APPEAL SUMMARY

Appeal ID: 22227	Project Address: 7200 NE Airport Way
Hearing Date: 12/18/19	Appellant Name: Tom Jaleski
Case No.: B-002	Appellant Phone: 9712385266
Appeal Type: Building	Plans Examiner/Inspector: David Bartley
Project Type:	Stories: 2 Occupancy: A-3, B, M, S-1 Construction Type: I-A
Building/Business Name: PDX	Fire Sprinklers: Yes - throughout
Appeal Involves: Erection of a new structure	LUR or Permit Application No.:
Plan Submitted Option: pdf [File 1]	Proposed use: Airport

APPEAL INFORMATION SHEET

PORTLAND INTERNATIONAL AIRPORT
PDXNEXT TCOE
ENPLANING - COORDINATION PLAN

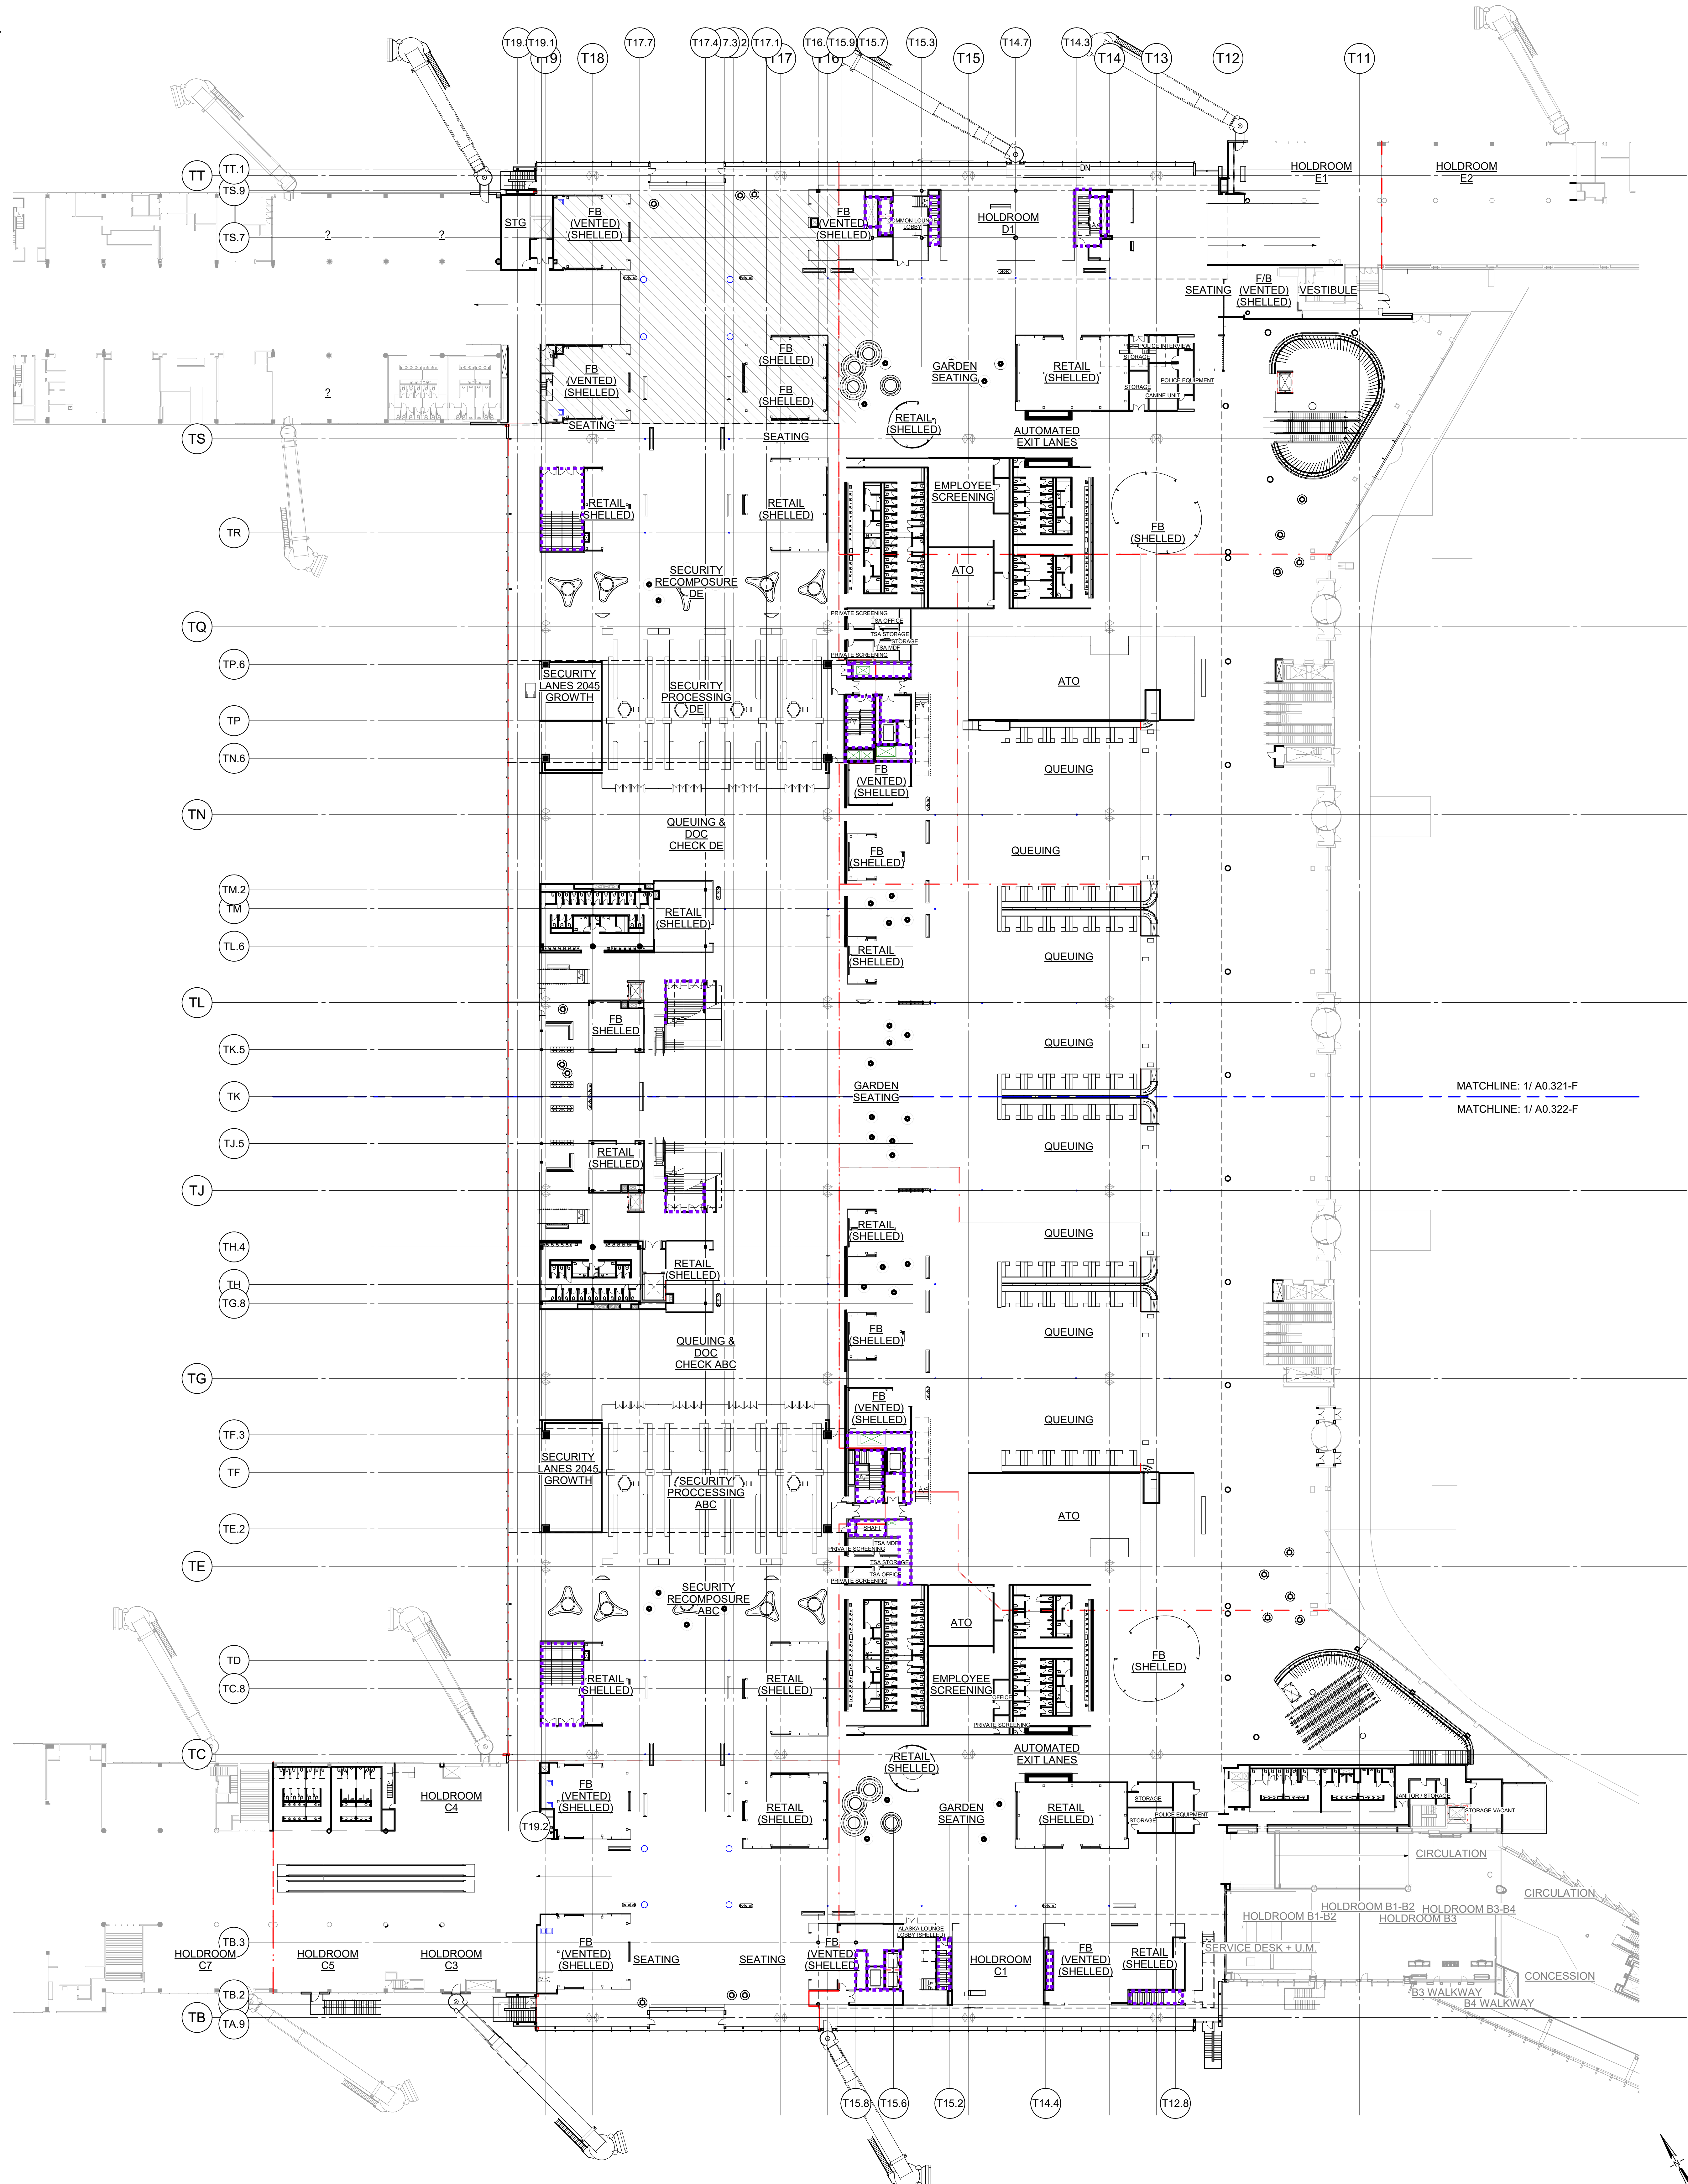
The exit passageways at the level of exit discharge do not extend to the building face to accommodate sightlines for baggage tug traffic and stopping distances for safety concerns with that traffic. The outdoor extensions of the exit passageways will be fully lit, sprinklered, open to the outside with 14'-8" high ceiling over the area and secure. The outside extensions will be tall enough to maintain tenability levels over the extension, with at least one full side open to the outside to prevent buildup of heat and smoke.

Exit passageway discharge within building: Hold for additional information.

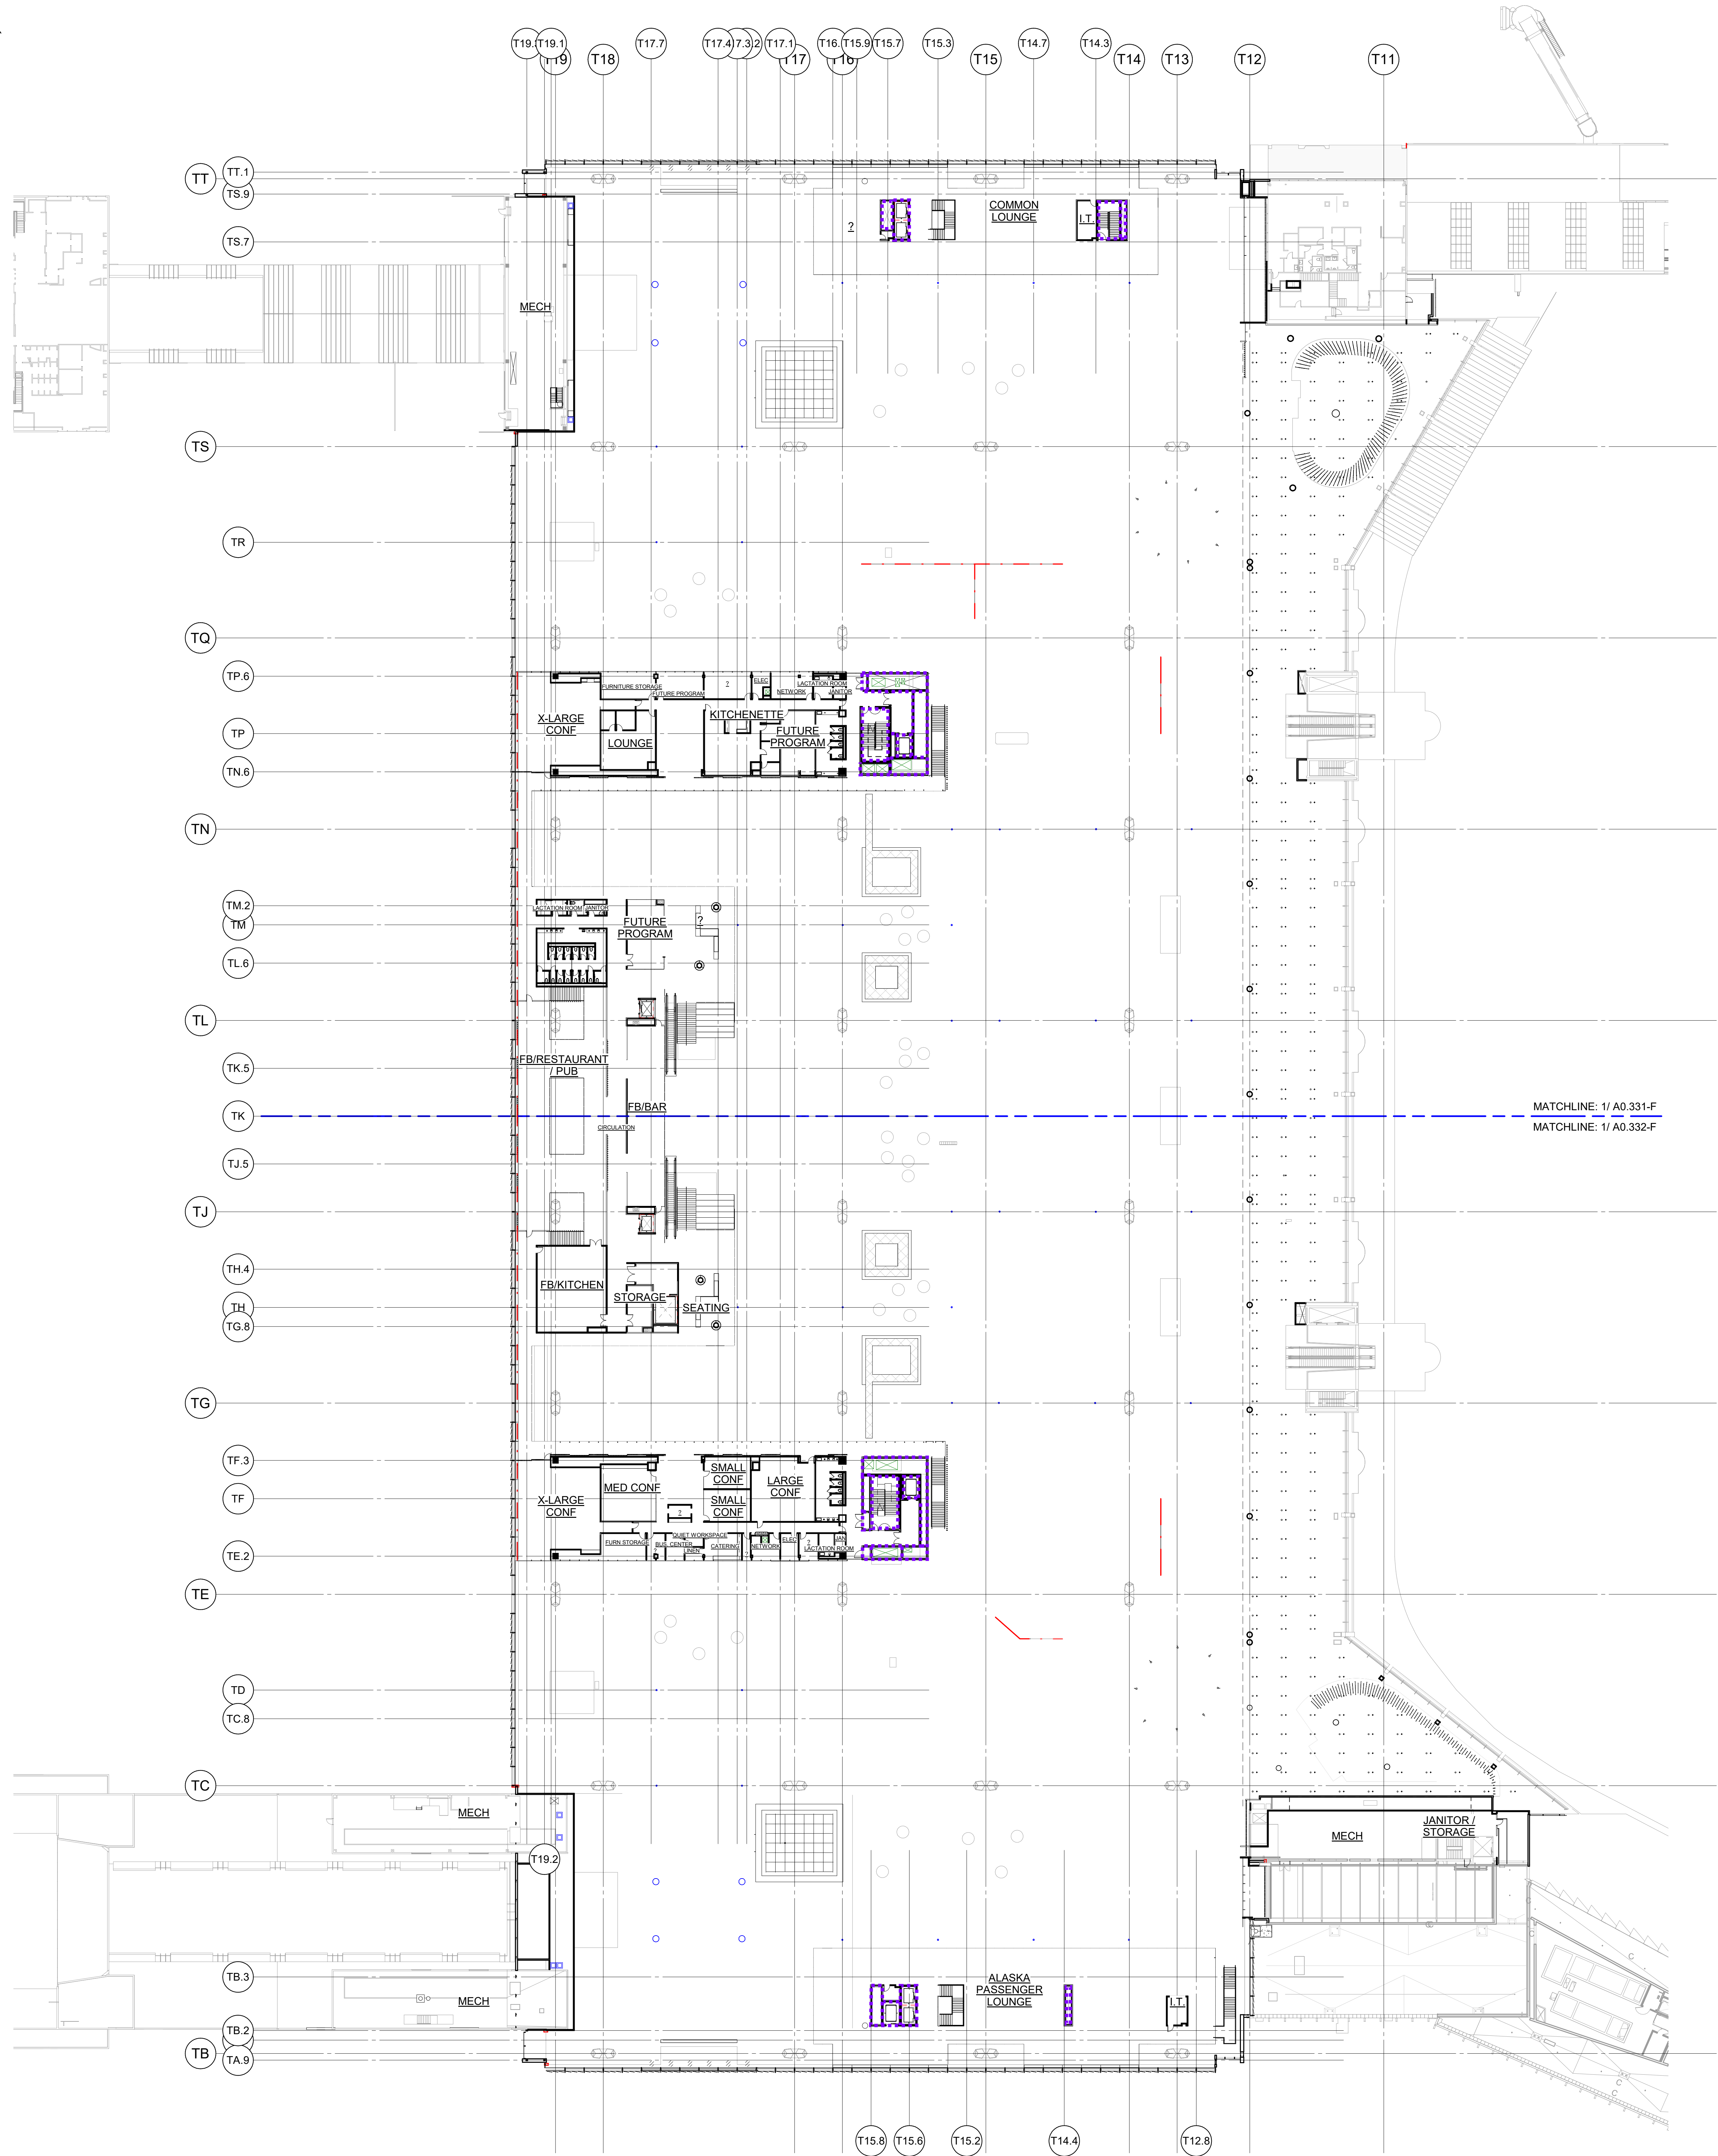
The proposed design for the PDX TCORE project will provide designated open-air exit passageways that meet the requirements for the 2019 OSSC 1023.3.1 Extension in that an Exit Passageway is provided from the interior exit stairway. The exit passageway from the interior exit stairway will meet all the requirements of an exit passageway per 2019 OSSC 1024, except the termination will not be through doors at the building face. The short path between exterior doors of the exit passageway and the building face will meet the requirements for no more than 50% of egress through areas on the level of exit discharge per 2019 OSSC 1028.1, exception 1 and provide the following equivalent protection measures:
